Serial No. NA3-14-030B
Docket No. 52-017
COL/RGM

DOMINION VIRGINIA POWER
NORTH ANNA UNIT 3 COMBINED LICENSE APPLICATION
SRPs 03.07.02 AND 03.08.05:
RESPONSE TO RAI LETTERS 123 AND 125

RAI No. 7536, Question 03.07.02-11

QUESTION NO.: 03.07.02-11

Figure 1: Comparison of Horizontal Full Column DRS for the CB Full Column Profile at Two Different Elevations

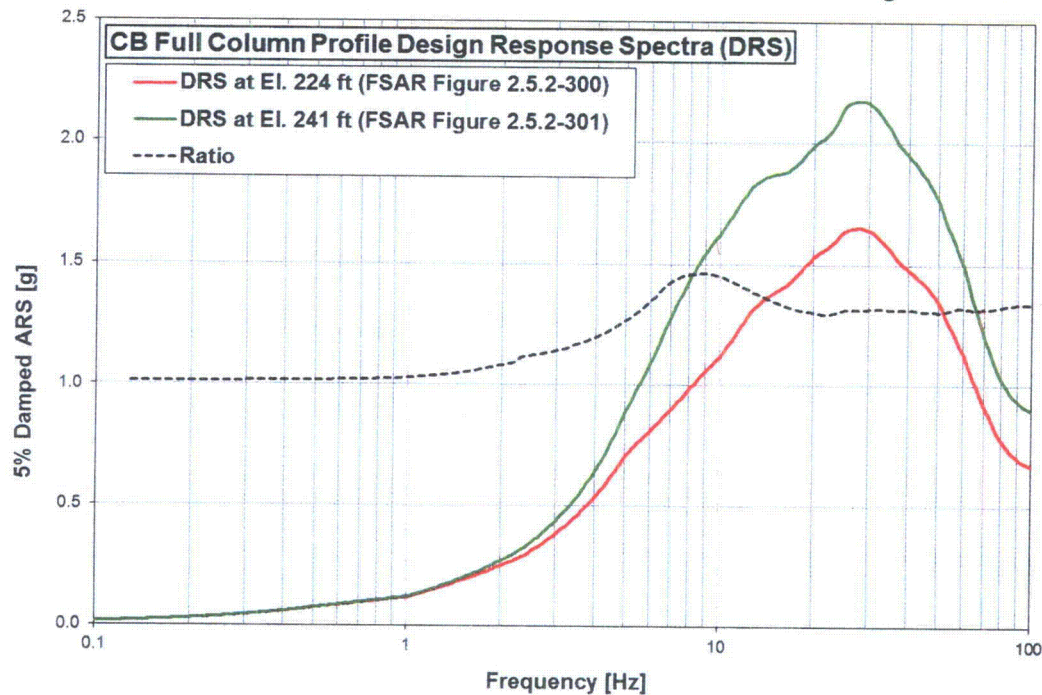
FSAR 3.7.2.4.1 indicates that SSI input control motions for the CB are defined at the bottom of the CB foundation basemat, which is consistent with the development of the SSI inputs described in FSAR 3.7.1. However, FSAR Section 3.7.2.4.1.1 indicates that the concrete fill below the CB basemat is an integral part of the structural model used in the SSI analysis (FSAR Figures 3.7.2-205 and 206). Since the combined CB-concrete fill is modeled as an integral structure, the control motions for SSI analysis should be defined at the bottom of the concrete fill to be consistent with the guidance in ISG-17, which the applicant has committed to. The staff also notes that the difference in elevation between the bottom of the basemat and the bottom of the concrete fill is approximately 5 m. Therefore, the applicant is requested to provide the technical justification for defining the SSI input control motions for the CB at the bottom of the basemat and not at the bottom of the concrete fill.

To evaluate the impact of defining the SSI input control motions for the CB at the bottom of the basemat and not at the bottom of the concrete fill, a comparison of the DRS was performed. Figure 1 presents a comparison of the horizontal full column DRS for the CB full column profile at these two different horizon elevations as described above. Figure 2 presents a comparison of the horizontal partial column DRS for the CB partial column profile at the two different horizon elevations. The ratio of the DRS at elevation 241 ft NAVD88 and the DRS at elevation 224 ft NAVD88 is also presented in each figure with a dashed line for ease of comparison.

The comparison of the DRS at elevation 241 ft NAVD88 and the DRS at elevation 224 ft NAVD88 shows that upward propagation of the seismic waves through the rock from bottom of the concrete fill to the bottom of the CB foundation does not result in shifts of the frequency content of the input motions towards lower frequencies or reduction of the high frequency amplitudes. Therefore, the input control motion used for the site-specific SSI analyses of the CB defined at basemat bottom elevation is acceptable and does not affect the results of the site-specific seismic evaluation or the design of the CB.
